RE: DA23/0598 - OURA STATION 2056 (2052) Oura Rd OURA - Abattoir & Power Station

Supplementary Objection Reasons to Amended Development Application

This submission prepared by the Oura Riverine Protection Inc. (ORP) provides an assessment of the Amended Development Application (DA) and the Applicant's response to Requests for Information (RFI) by NSW EPA and DPI Agriculture.

Figure 1: Site Conceptual Map

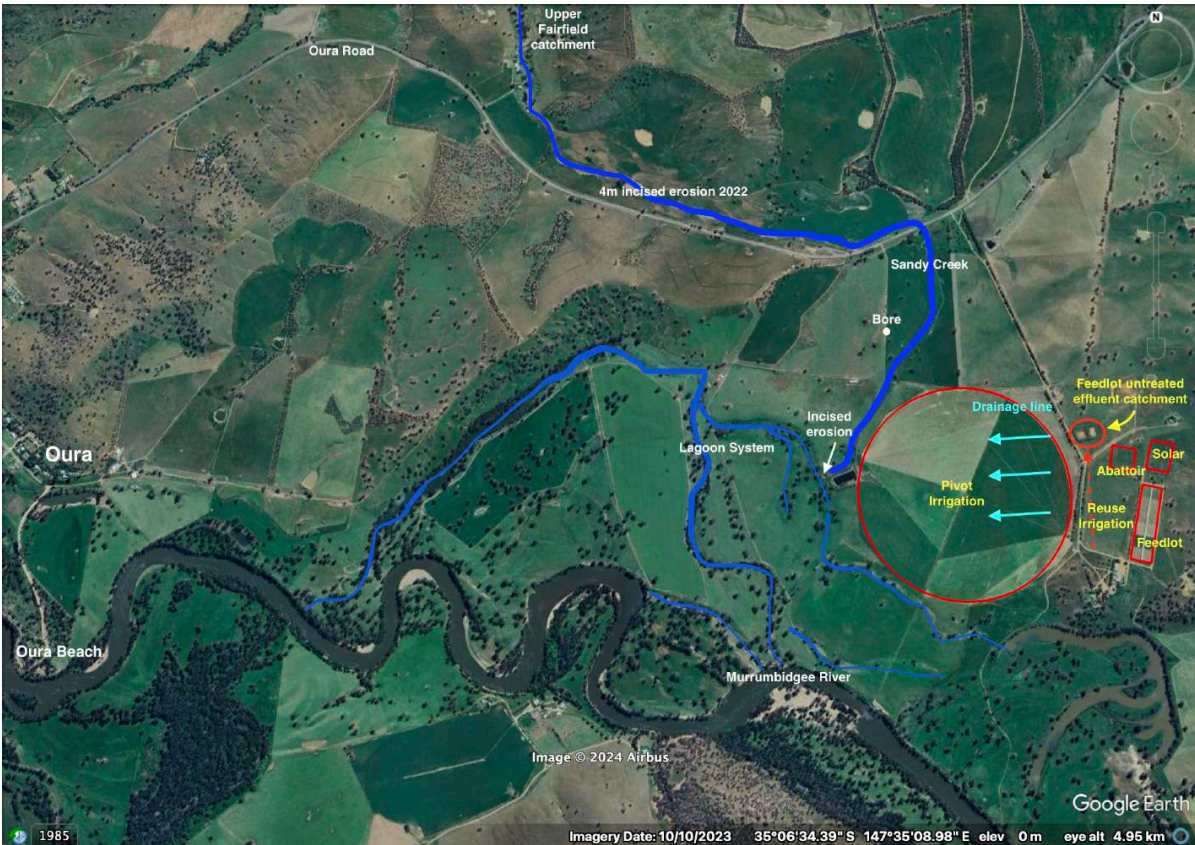
- The Applicant continue to ignore existence of closest neighbour’s bore 40WA416489 (license number and location previously supplied) (Figure 1).

Figure 2: Site Wide Runoff Model

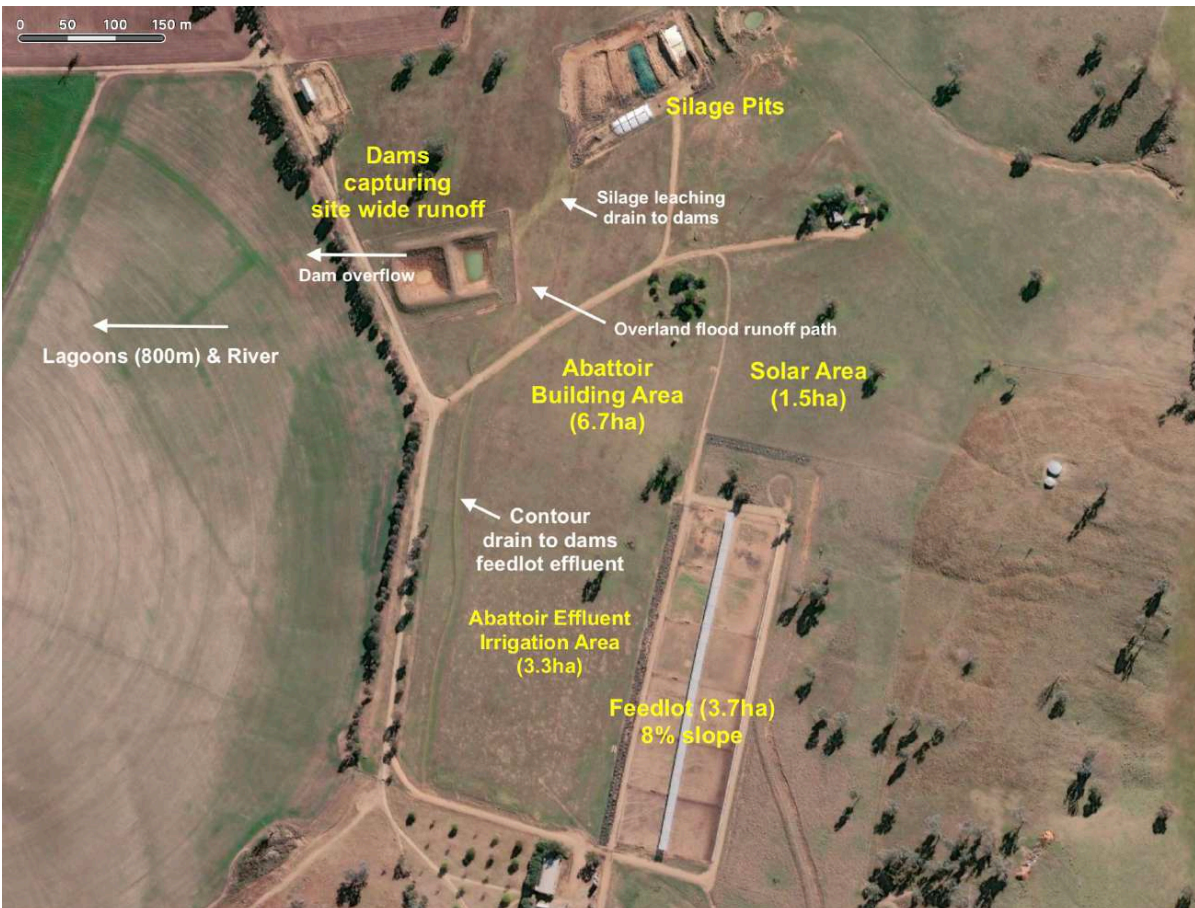
- Runoff from the feedlot will flow over the effluent irrigation area which is on a 6% slope (Figure 6).
- The runoff is then directed via a contour to the dams on the north side of the site, also unassessed, which overflow to the flood plain (Figures 1 & 2).

- The dams on the north side of the site also capture leaching from silage pits located above the dams and will capture flooding through the proposed abattoir buildings as modelled by Martens in the Amended DA (Figures 2 & 4)

Figure 4: Flood Model PMF

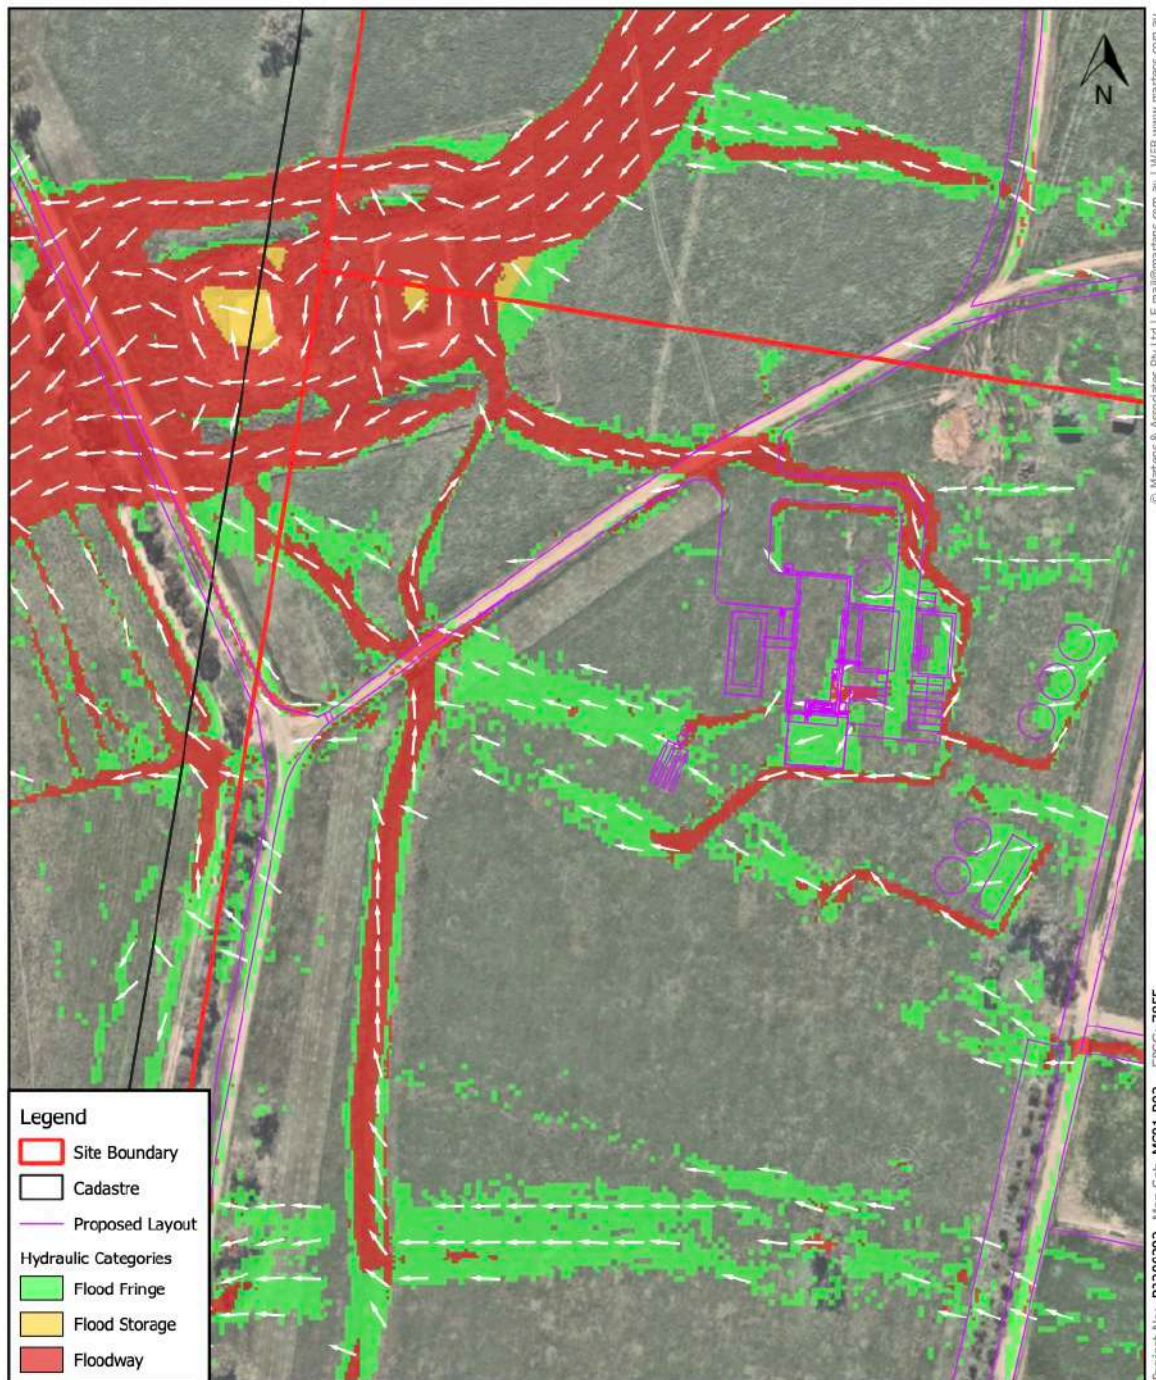
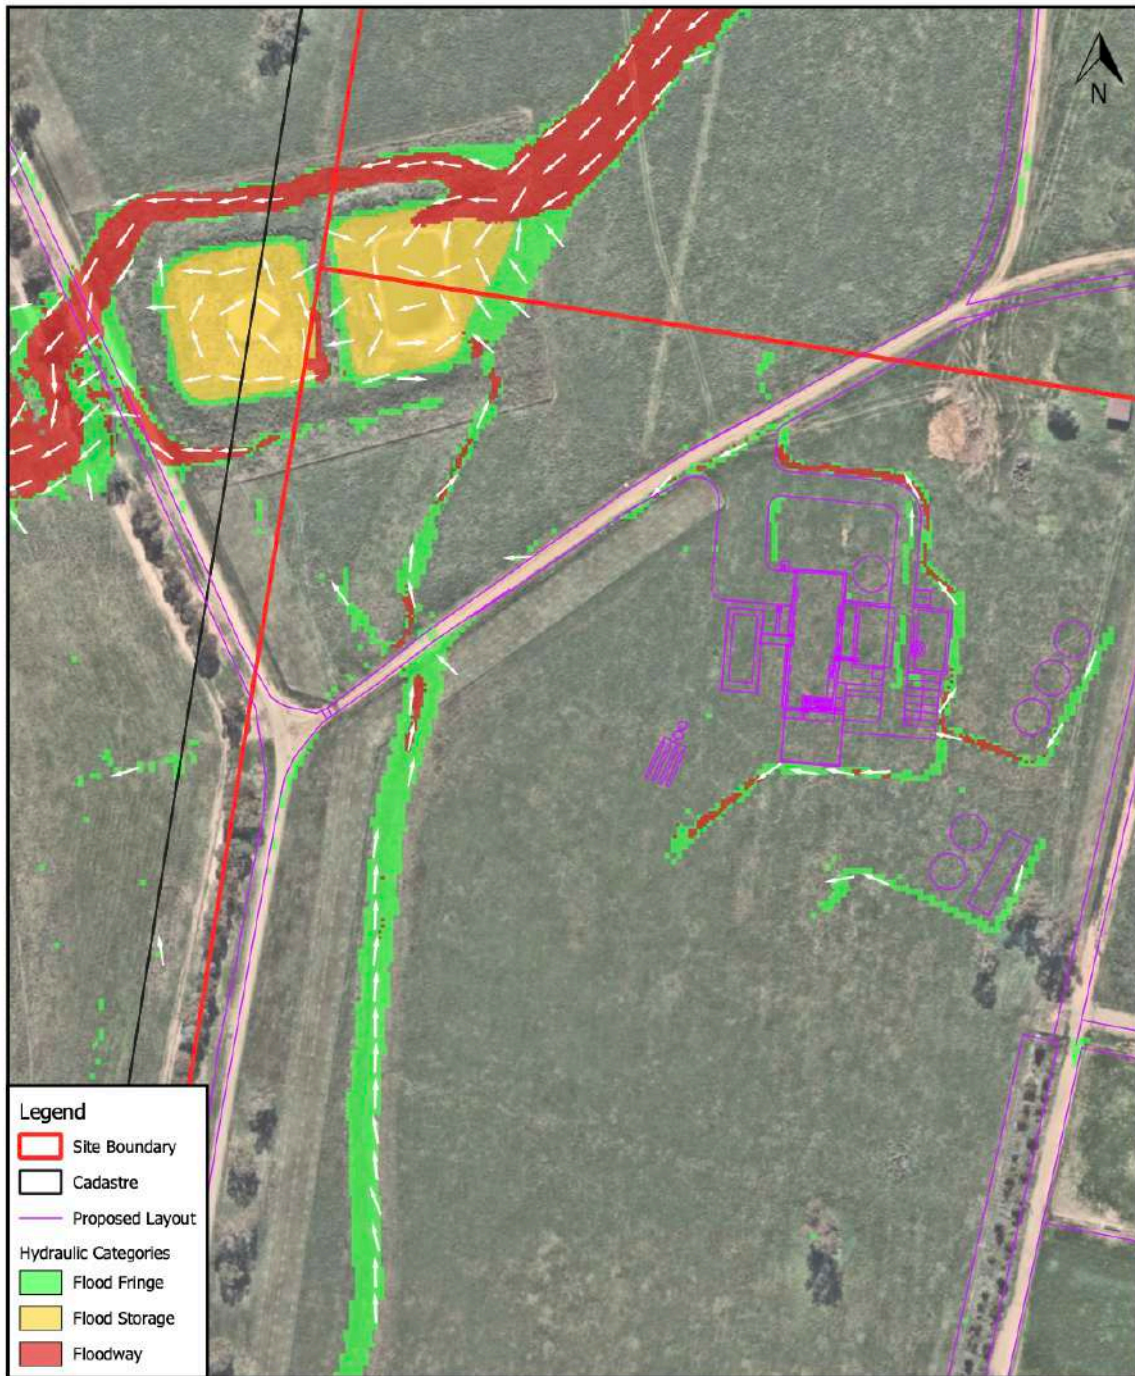
- Martens PMF Critical Storm modelling (Figure 4) shows the site wide flood pathways from the contour below the effluent irrigation area and the feedlot, the watercourse from the east down slope via the silage pit area, as well as through the abattoir/buildings area below the solar array, to the dams on the north side of the 12 hectare site and from there overflow to the floodplain (Figure 2). The 1% AEP Critical Storm model (Figure 5) also shows the same flow pathways.

Figure 1: Average slope through existing drought feedlot (beef cattle)

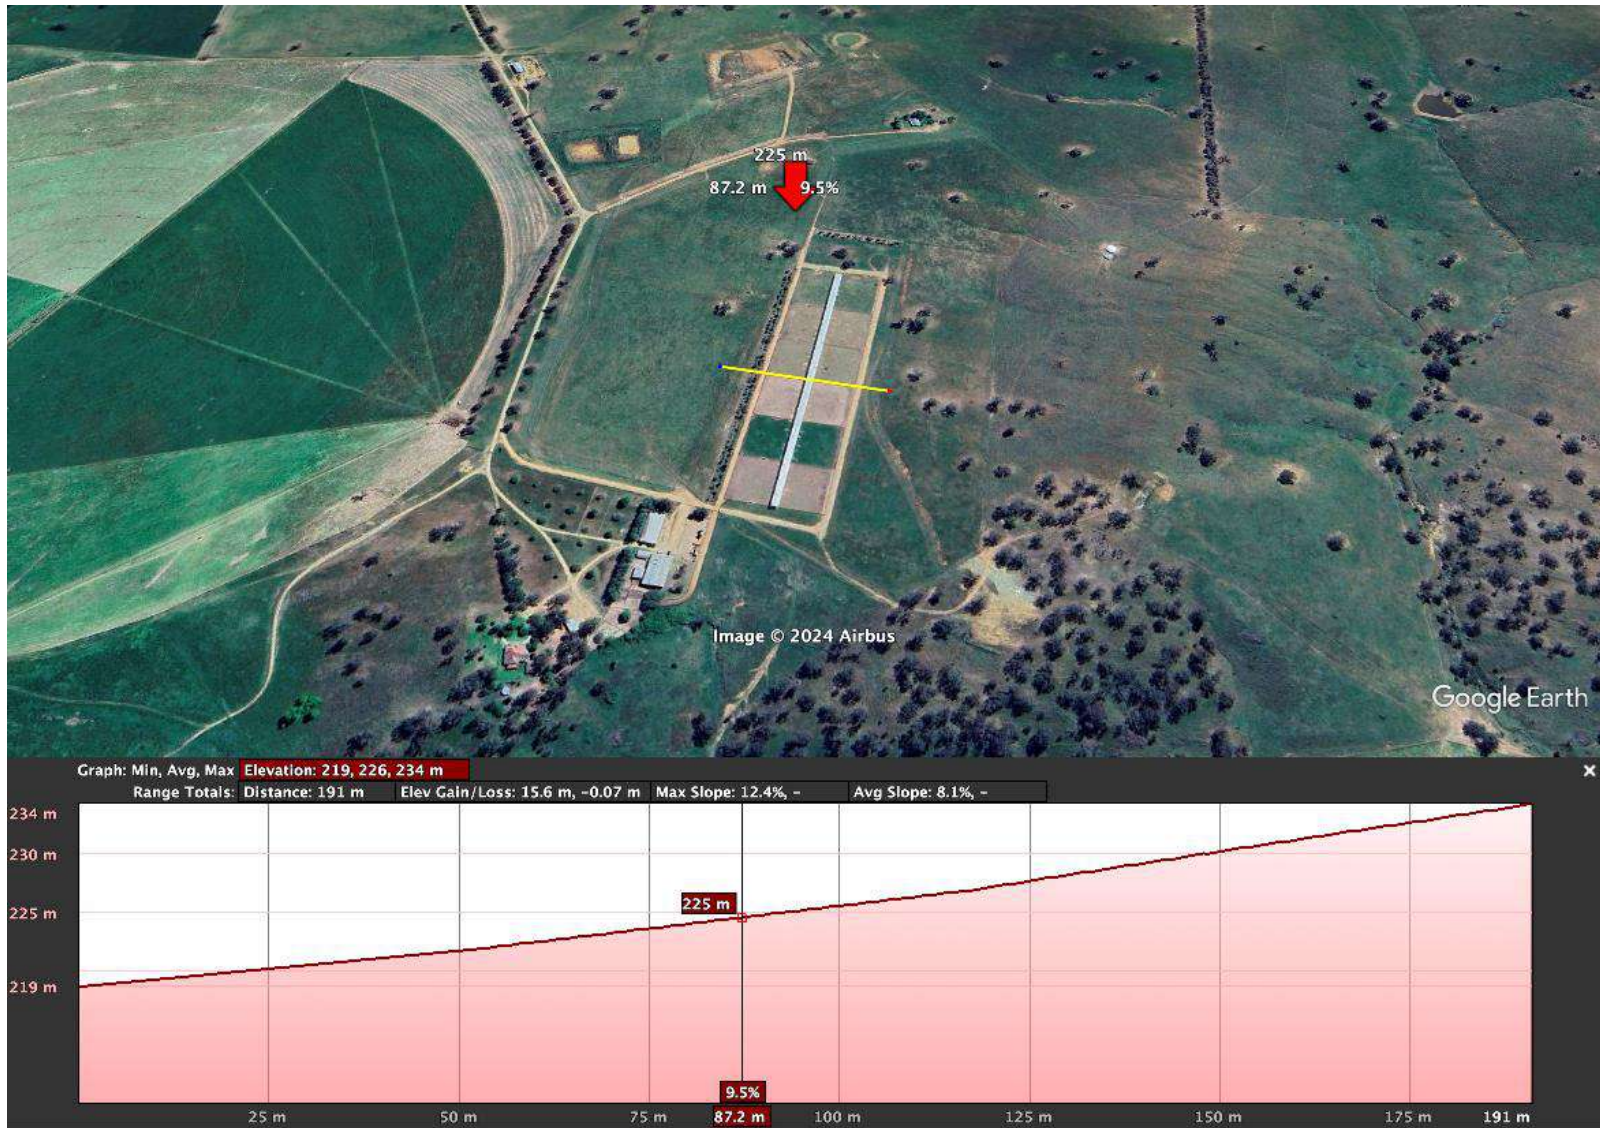
8. The feedlot slope from bunk-line to back gate appears to be about 8% (refer Figure 1) which would provide significant runoff velocity and possible entrainment of manure in most rain events over 5mm in one day.
